APPLICANT: Rex D. Howton
PHONE: 770-827-5772
REPRESENTATIVE: Ronnie Ardis
PHONE: 770-560-4407
TITLEHOLDER: Rex D. Howton
PROPERTY LOCATION: On the east side Valley Reserve, south of Mountain Reserve (1381 Valley Reserve).

PETITION No.: V-153
DATE OF HEARING: 11-11-2015
PRESENT ZONING: R-20
LAND LOT(S): 245
DISTRICT: 20
SIZE OF TRACT: 0.93 acres
COMMISSION DISTRICT: 1

TYPE OF VARIANCE: 1) Waive the maximum allowable impervious surface from 35% to 56.14%; 2) waive the setback for an accessory structure over 650 square feet (existing approximately 960 square foot frame bath house with overhang) from the required 100 feet to 18 feet adjacent to the southern property line and to 50 feet from the rear; and 3) waive the setback for an accessory structure over 650 square feet (proposed approximately 1,400 square foot garage with overhand) from the required 100 feet to 6 feet adjacent to the northern property line and to 65 feet from the rear.

APPLICANT: Rex D. Howton **PETITION No.:** V-153

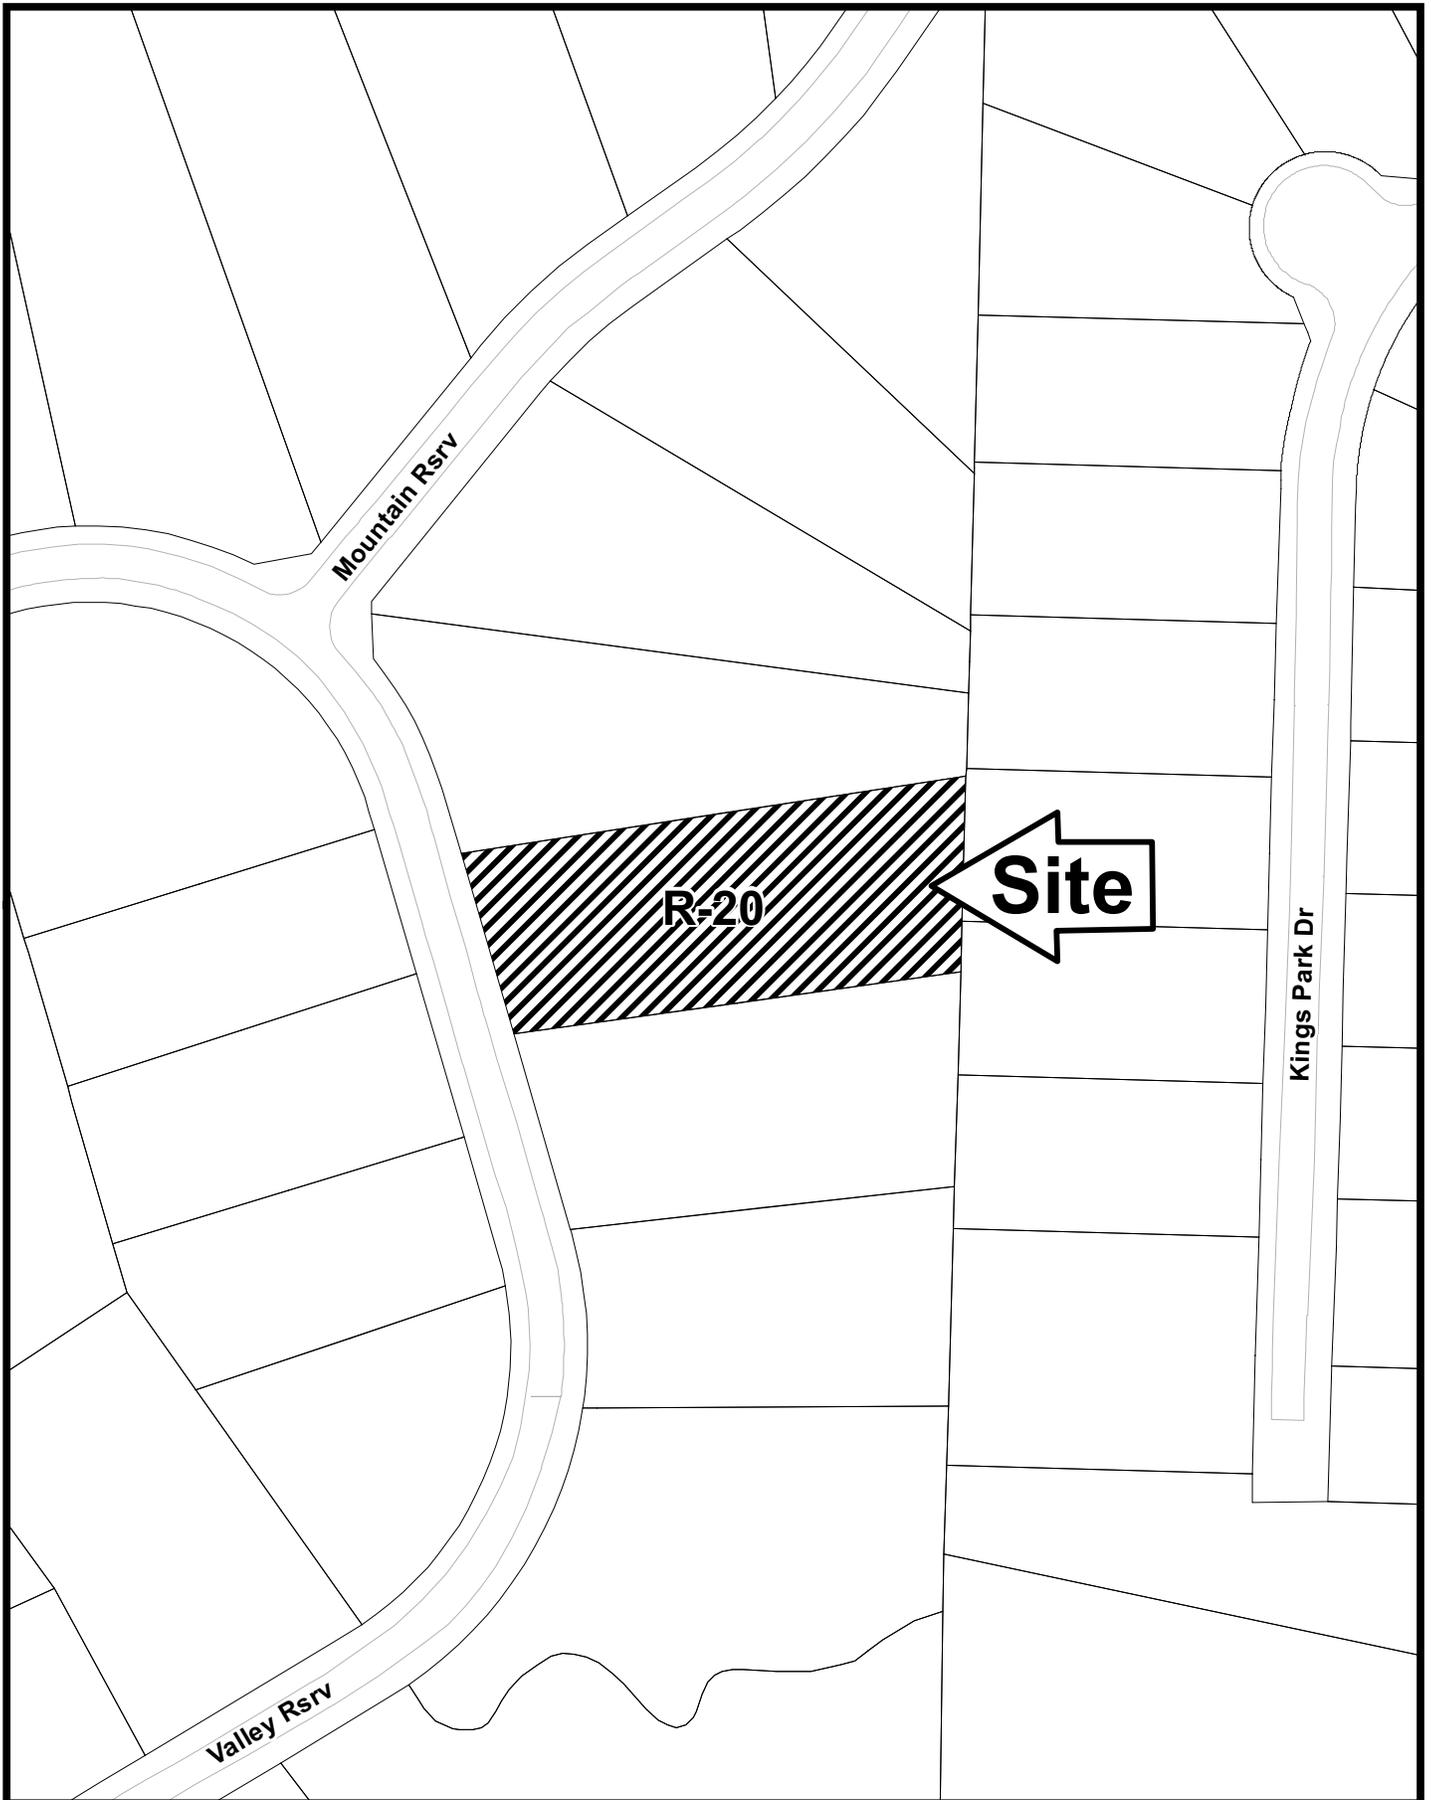
SITE PLAN REVIEW: If this variance request is approved, a subdivision plat revision must be recorded prior to the issuance of the certificate of occupancy showing all improvements on the lot and referencing the variance case in the standard plat revision note. The surveyor must submit the plat to the Site Plan Review Section, Community Development Agency for review and approval prior to recording. Call 770-528-2147.

STORMWATER MANAGEMENT: This lot is already significantly over the 35% allowable impervious coverage for an R-20 parcel. The proposed improvements will increase the effective coverage to over 56%. If this variance is approved, a drywell infiltration system must be approved by the Stormwater Management Division and installed to mitigate the additional site runoff volume.
